Construction Division
Additions & Alteration Charges Approval Form

Gulmohar Residency

Extra Specifications flat no D-503

Details of Additions & Alterations

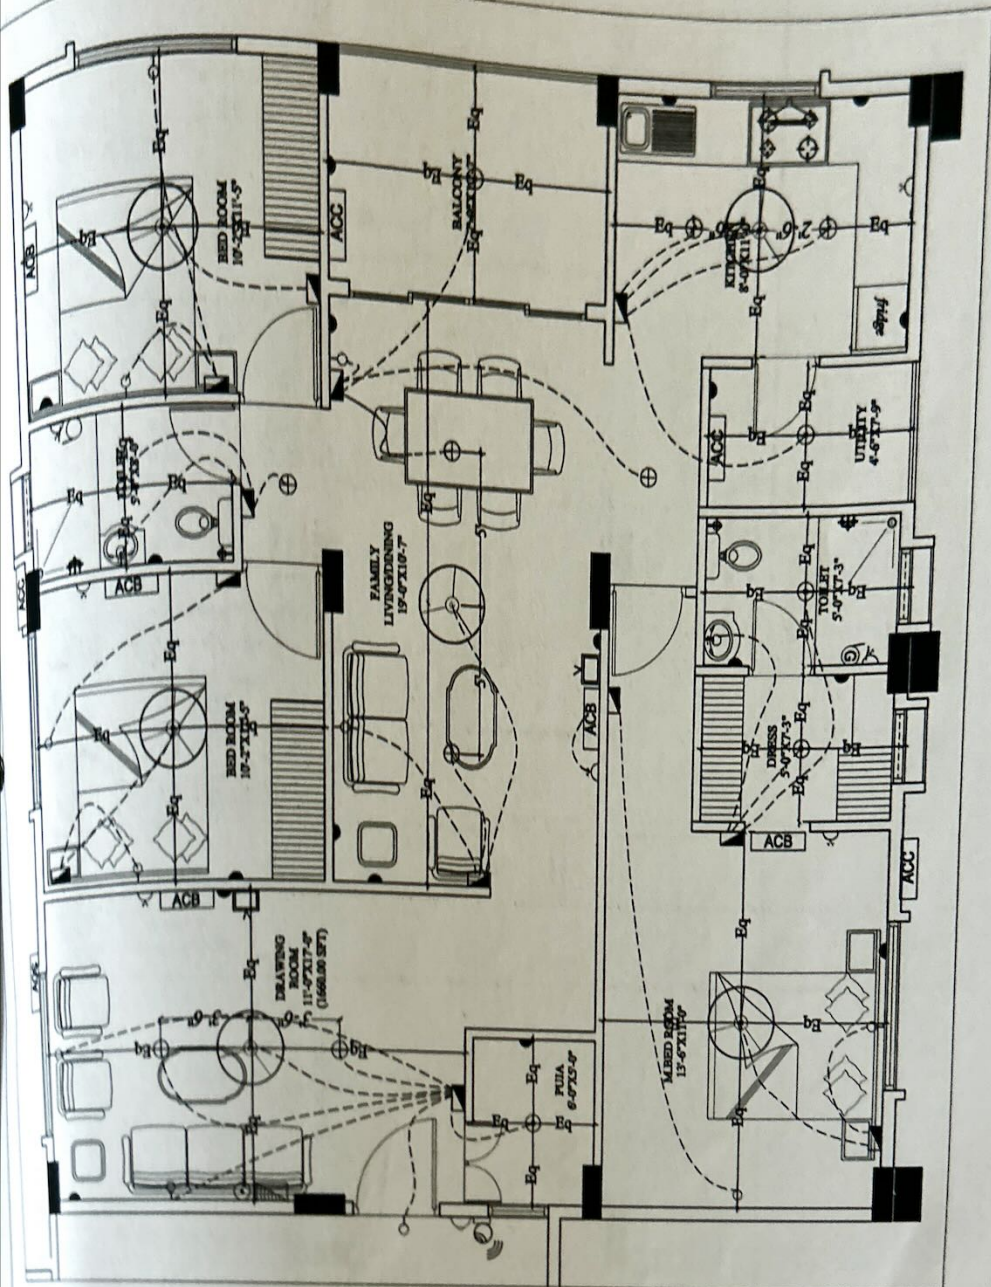
Changes in flooring:

- 1) Master toilet - Malayism Brown -
- 2) Common toilet - Ultra Sprinkle -
- 3) Hall & Dining & Kids Bedroom - Pegal Beige
Kitchen - Pegal Beige
- 4) Master Bedroom & Guest Bedroom - Urban wood natural
Pegal Beige

cancelled
